Internal photos

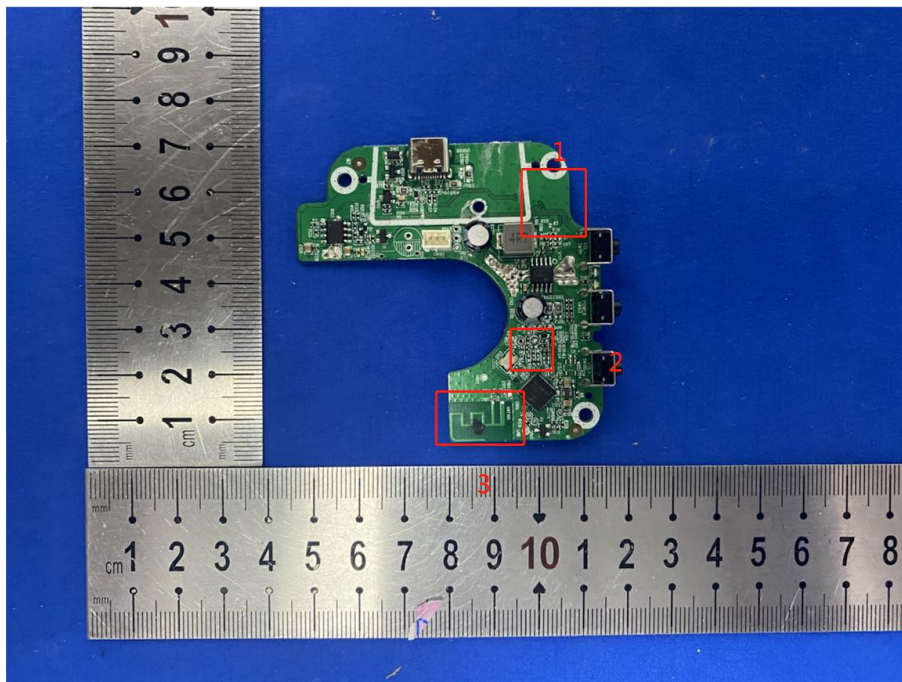
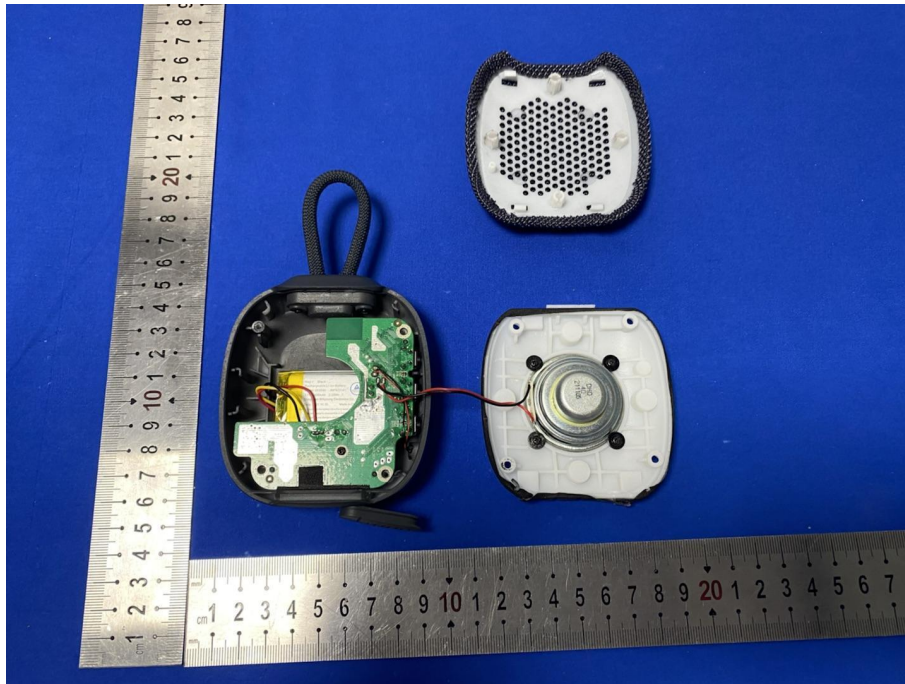
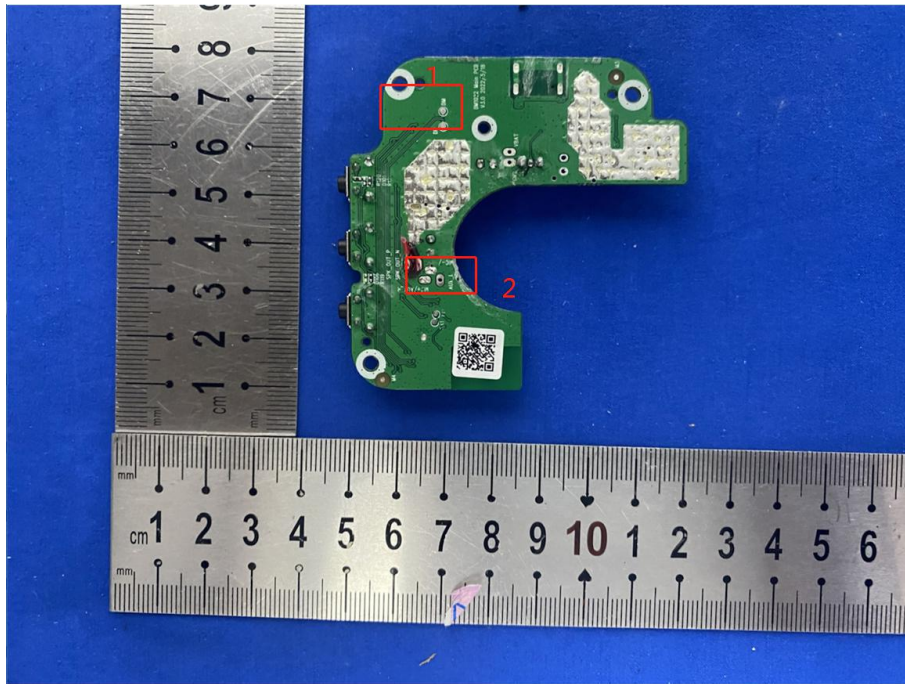
The solder joint test was cancelled at position 1, the line layout was optimized at position 2, and the antenna was lengthened at position 3

The solder joint test was cancelled at position 1, and the line layout was optimized at position 2
